#### Memorandum

Date:	August 19, 2015
From:	Marie Ennis, Gabriel Pardo
To:	John Shedd
Company:	Chautauqua Institution
c:	
Project:	Chautauqua Institution Amphitheater Study: Narrative and Questions
Project #:	J3262.02

Chautauqua Institution Amphitheater. **Demo-Construction Sequence**

Drawing No. S-SEQ-202.00

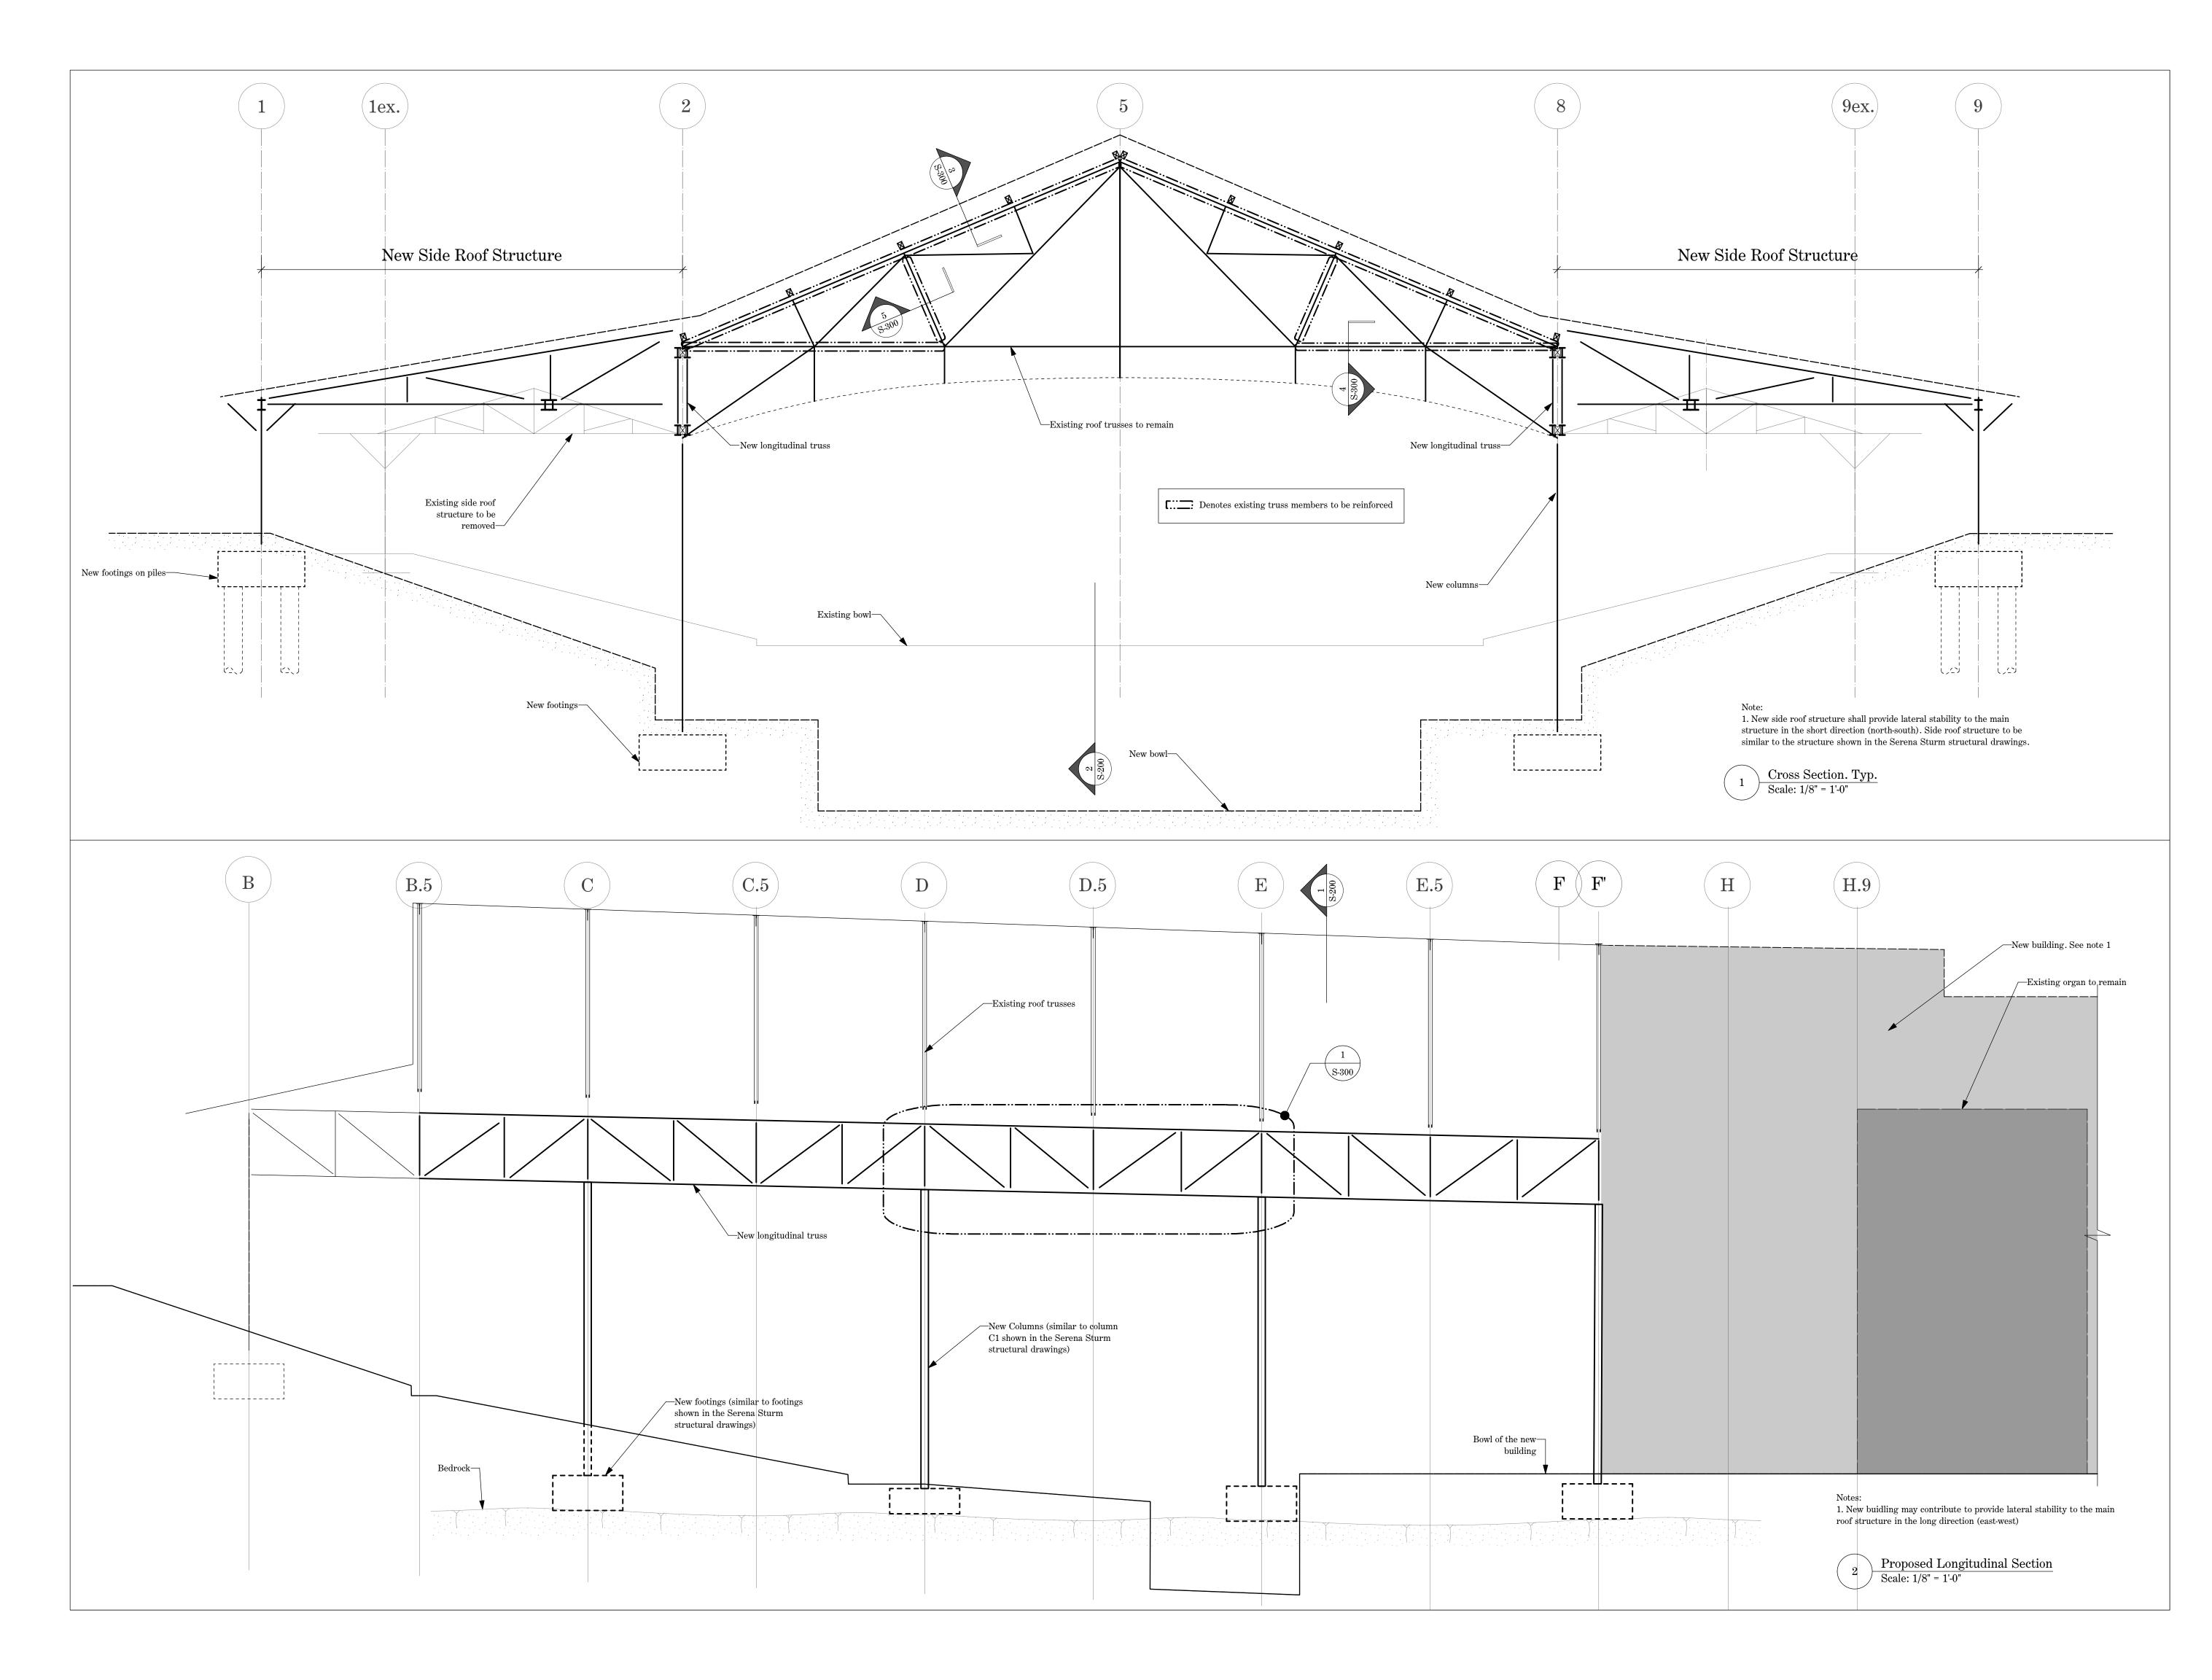
Note A: "Longitudinal truss shall be connected to new east end building to provide lateral stability". It is not clear if the modifications presented in Option A create a selfsupporting structure of if the structure transfers loads into the "New Building" as shown as Out of Scope. Due to the limited amount of space that the "New Building" occupies, it is unlikely that the new building will be able to support any magnitude of lateral load.

The general notes on S-SEQ-001 state that not all of the design goals for the full demolition/new building could be accommodated and keep the main roof in place, therefore other non-structural aspects of the design would need to be revised accordingly. Step 4:We agree that Option B has some advantages over Option A.Step 5:Resolved by using micro-piles or mini-caissons.Steps 6 & 7:See Option A Step 6.
